To: T10 Technical Committee
 From: Rob Elliott (elliott@hp.com) and Thomas Grieff (thomas.grieff@hp.com), HP
 Date: 11 July 2002
 Subject: T10/02-198r5 SAS OOB timing

The OOB timing requirements need to be more precise, listing the transmit burst time and specifying receiver tolerances. Various other minor changes are also included.

Figure 1. Phy reset sequence OOB signal generation transmission and detection

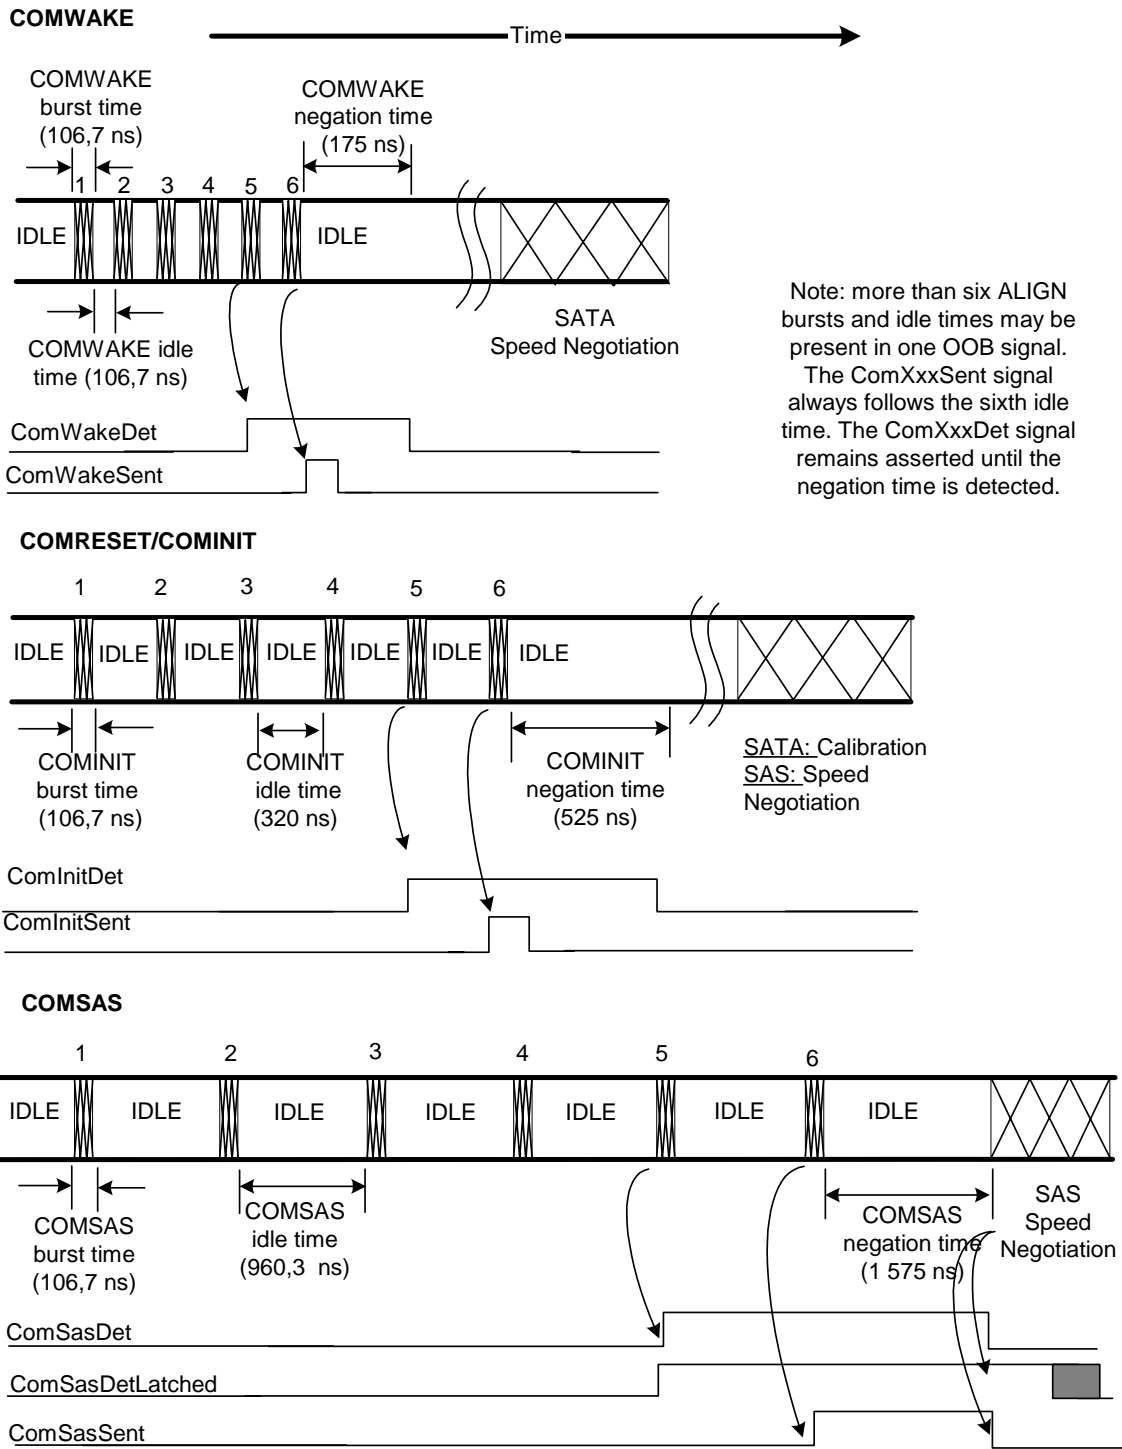
Figure 1 illustrates the timing required for the generation and detection of all the SAS OOB signals. The signals labeled ComXxxDet and ComXxxSent (where Xxx is Wake, Init, or Sas), are inputs to the SAS phy Initialization layer state machine. ComXxxDet is an output from the OOB detection circuitry that indicates the detection of an incoming COMINIT, COMWAKE, or COMSAS sequencesignal. ComXxxSent is an output from the OOB generation circuitry that indicates that a burst of six COMWAKE, COMINIT, or COMSAS sequencesignal has been output onto the link.

The ALIGNs used in OOB sequencesignallingsignals are not required to be at generation 1 (G1) rates (1,5 Gbps), as this rate might not be supported in future generations of SAS devices. The ALIGNs are only required to generate an envelope for the detection circuitry, as required for any signaling that may be AC coupled. If G2 ALIGNs are used, the number of ALIGNs doubles compared with G1 ALIGNs. Likewise tTheThe idle time for

Figure 36. SAS-to-SAS phy reset sequence

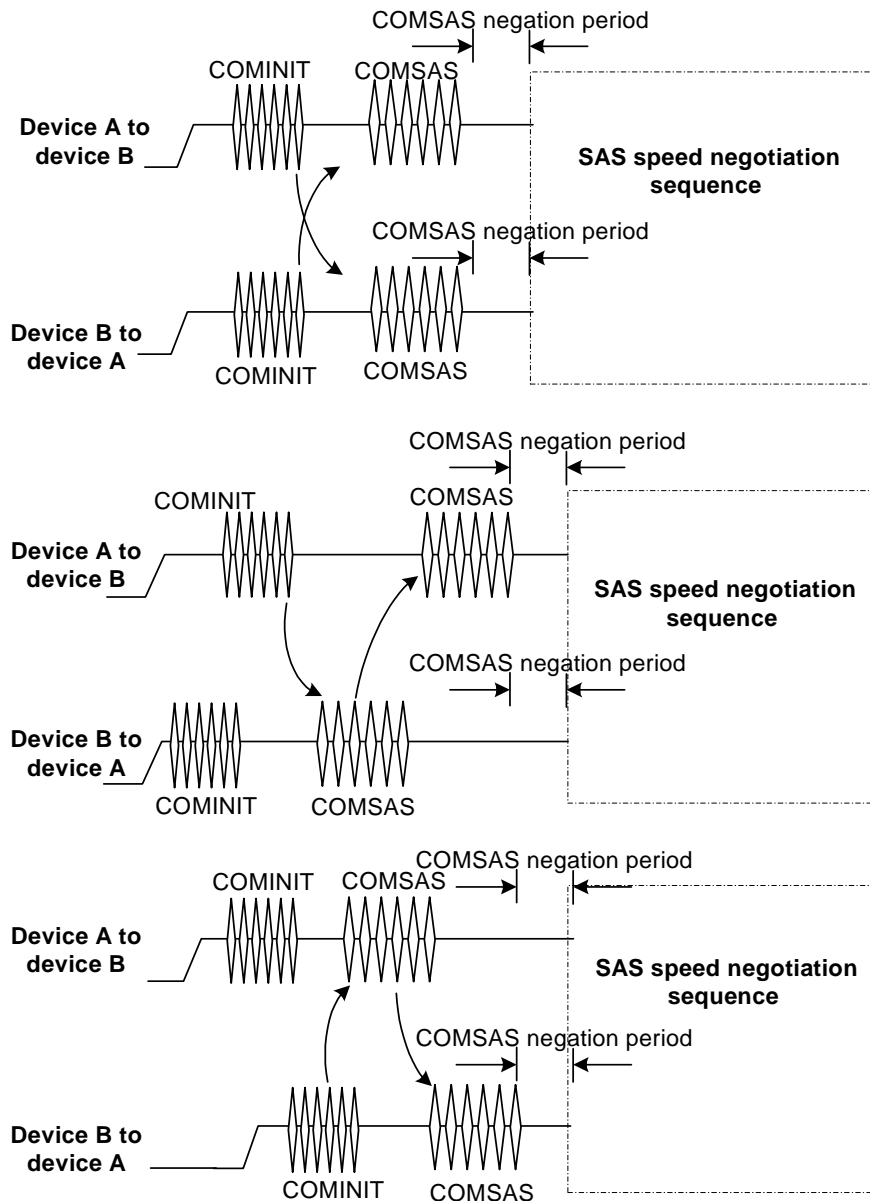
Figure 36 illustrates several different ~~power-up~~ sequences based on whether ~~one a~~ SAS phy powers up before, after, or at the same time as the SAS phy to which it is attached.

Figure 2. Speed Negotiation Window

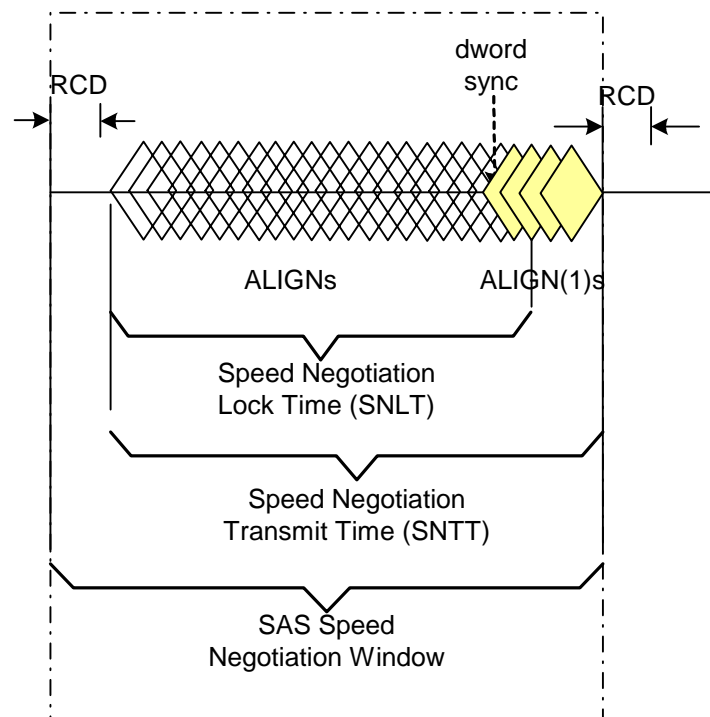
If the device supports the link rate, it shall attempt to synchronize on an incoming series of dwords at the same rate for the Speed Negotiation Lock Time. The incoming dwords may be ALIGNs or ALIGN(1)s. If the device achieves dword synchronization within the Speed Negotiation Lock Time, it shall change from transmitting ALIGNs to transmitting ALIGN(1)s for the remainder of the Speed Negotiation Transmit Time (i.e., the remainder of the Speed Negotiation Window). If the device does not achieve dword synchronization within the Speed Negotiation Lock Time, it shall continue transmitting ALIGNs for the remainder of the Speed Negotiation Transmit Time. Figure xx illustrates the Speed Negotiation Window.

Figure xx. SAS speed negotiation sequence (G1 only with G1 only)

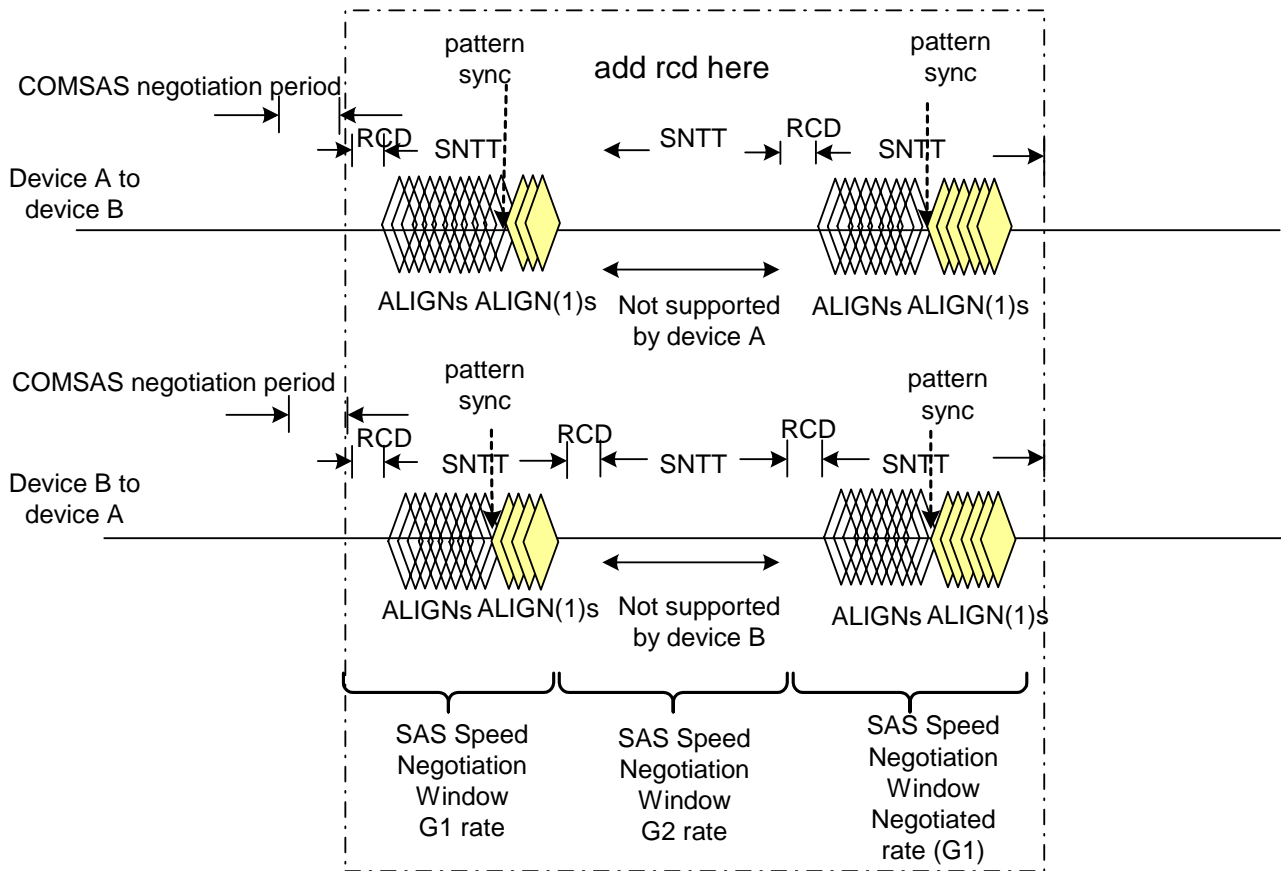
Figure xx shows a speed negotiation between a SAS device A that supports only the G1 link rate attached to a SAS device B that only supports the G1 link rate. They both run the G1 Speed Negotiation Window (valid) and the G2 Speed Negotiation Window (invalid), then select G1 for the final Speed Negotiation Window used to establish the negotiated rate.

Figure 37. SAS speed negotiation sequence (example 4-G1, G2, G3 with G1, G2)

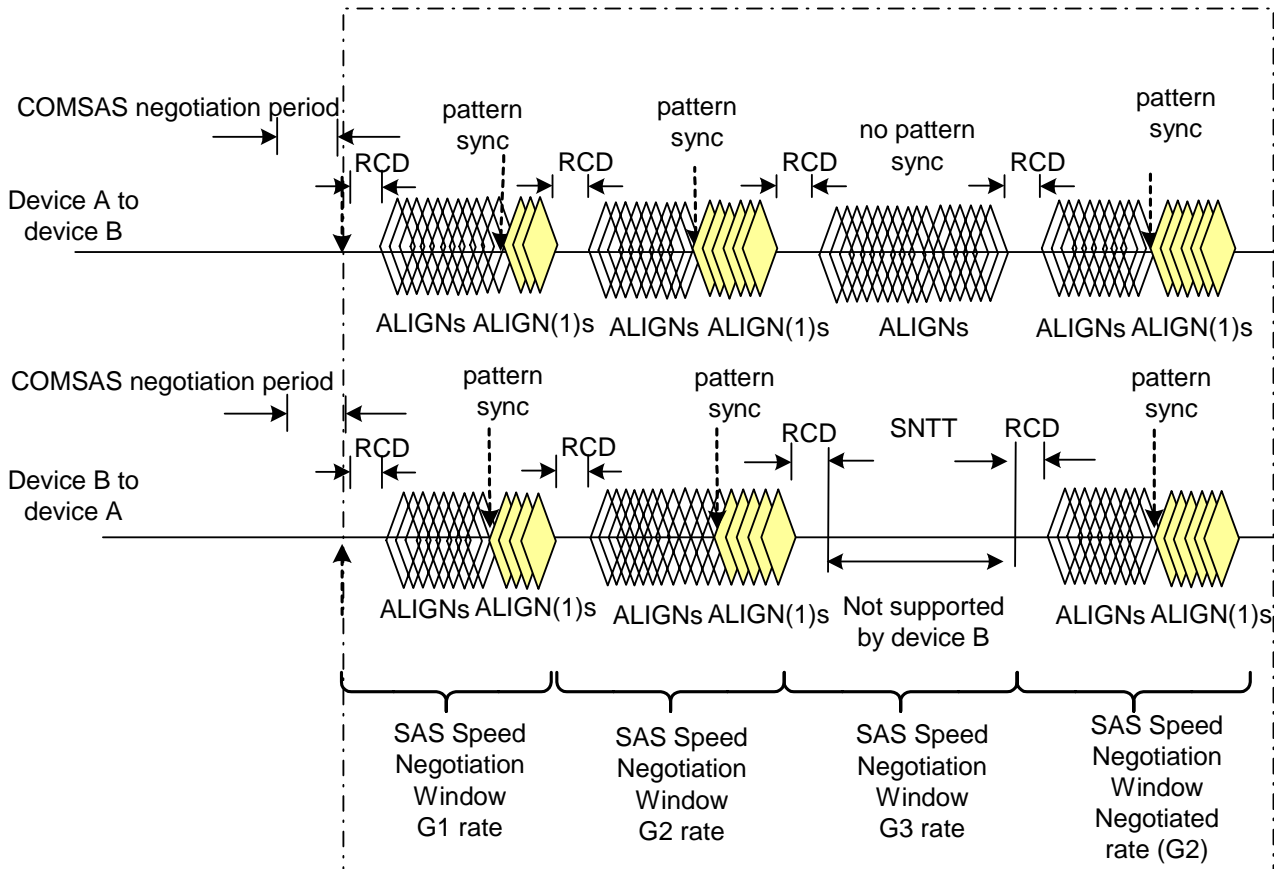
Figure 37 shows a speed negotiation between a SAS phy-device A that supports speeds-G1 thru G3 link rates attached to a SAS phy-device B that only supports speeds-G1 and G2 link rates. They both run the G1 Speed Negotiation Window (valid), the G2 Speed Negotiation Window (valid), and the G3 Speed Negotiation Window (supported by device A but not by device B, so invalid), then select G2 for the final Speed Negotiation Window used to establish the negotiated rate.

Figure 38. SAS speed negotiation sequence (example-2G1, G2, G3 with G2 only)

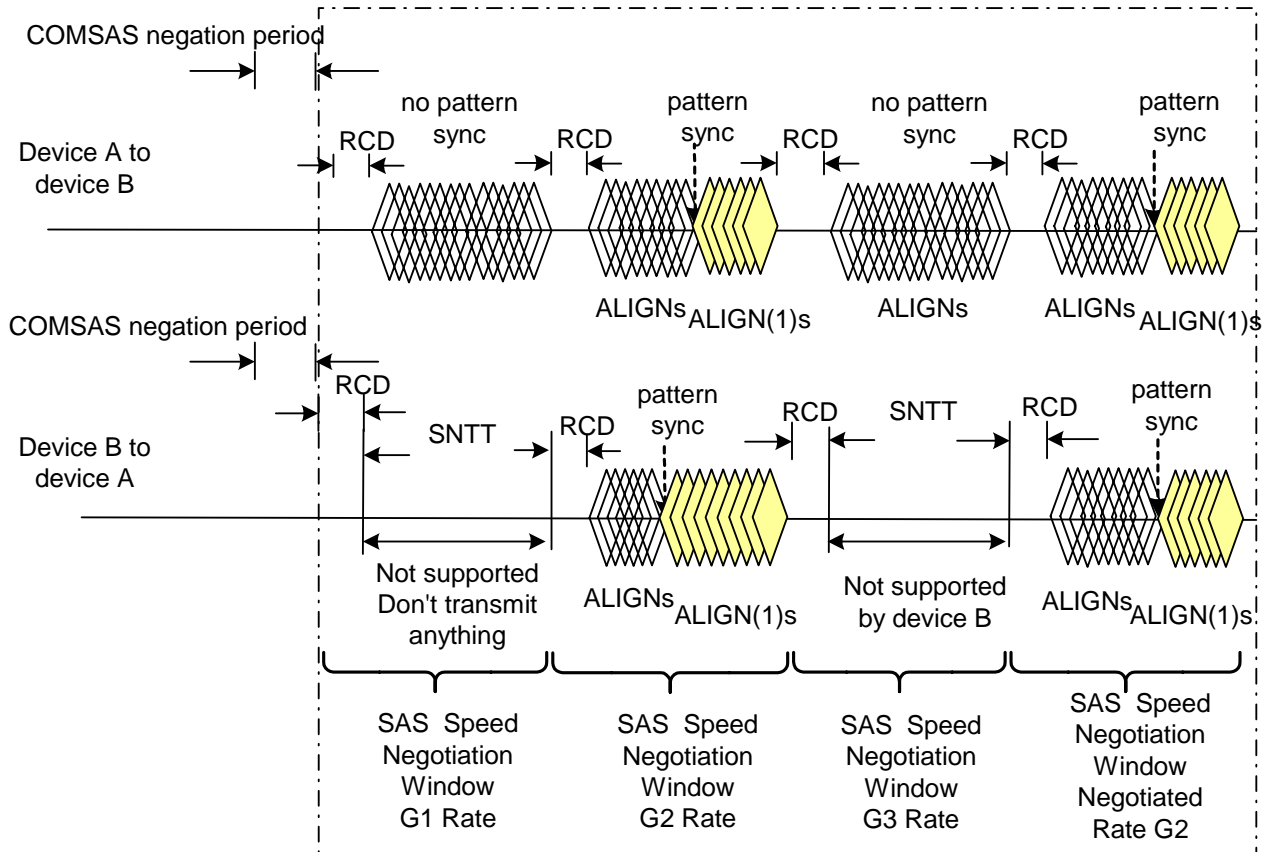
Figure 38 shows speed negotiation between a SAS device A that supports G1 thru G3 link rates and a SAS device B that only supports the G2 link rate. They both run the G1 Speed Negotiation Window (supported by device A but not by device B, so invalid), the G2 Speed Negotiation Window (valid), and the G3 Speed Negotiation Window (supported by device A but not by device B, so invalid), then select G2 for final Speed Negotiation Window to establish the negotiated rate.

Figure 39. SAS speed negotiation sequence (example 3G1,G2,G3 with G1,G2 and failure)

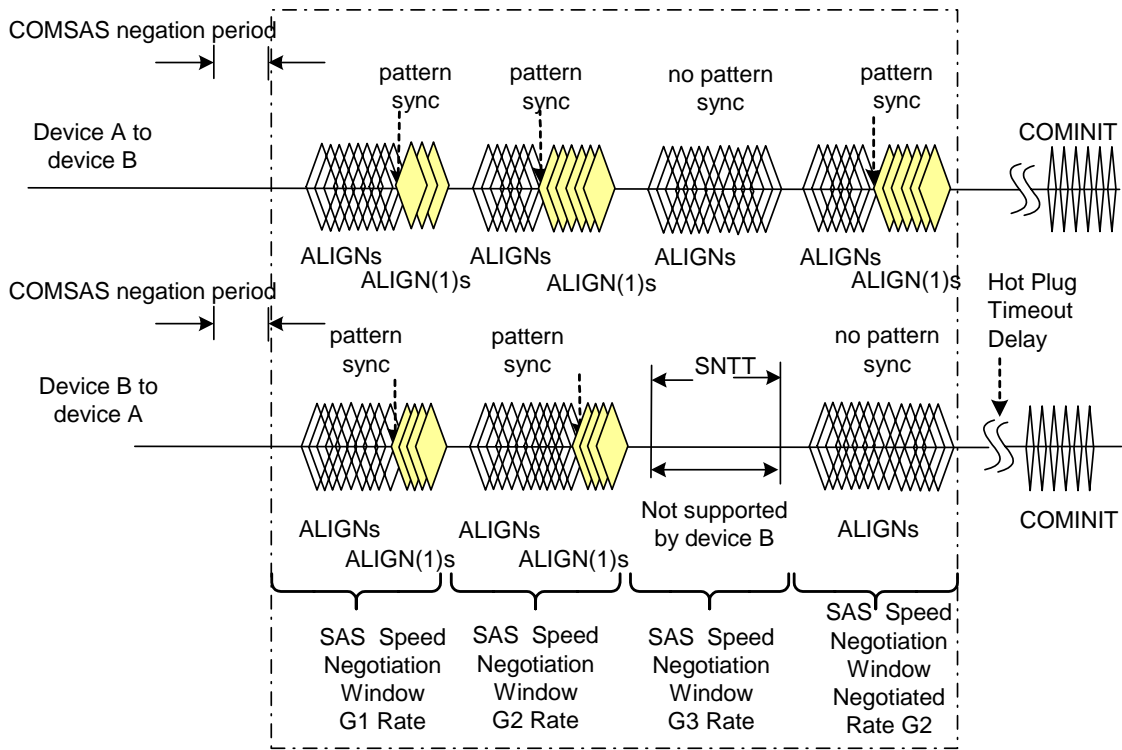
Figure 39 shows the same speed negotiation sequence as in Figure 37, except for some reason, one of the SAS device's PLLs does not obtain ~~pattern_dword~~ synchronization and detect ALIGNs during the final speed negotiation window. If this occurs, the handshake is not complete and the OOB sequence shall be retried starting with COMINIT, forcing the ~~link-phy~~ to retry the whole reset sequence.
